# ADA Curb Ramp New Construction Inspection Form (Combination)

NW 307th

23886.56

NW Pacific

COMBINATION RAMP (C)

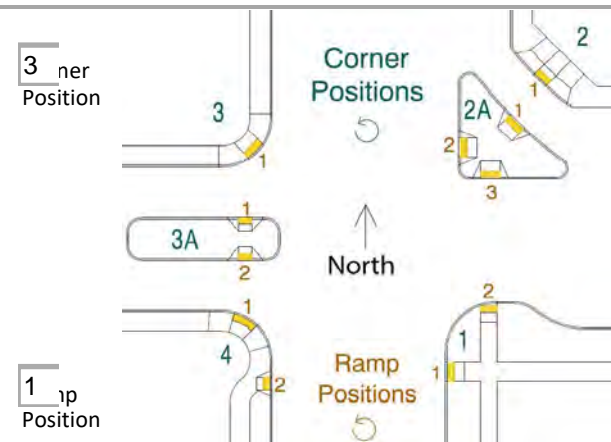
Running Slope 1

8.8

Counter Slope (+/-)\*<sup>2</sup>

6.3

Running Slope 2

11.7

3.4

Width X

3.0

3.0

3.0

TD not full width, more than 2", RR3-CRK
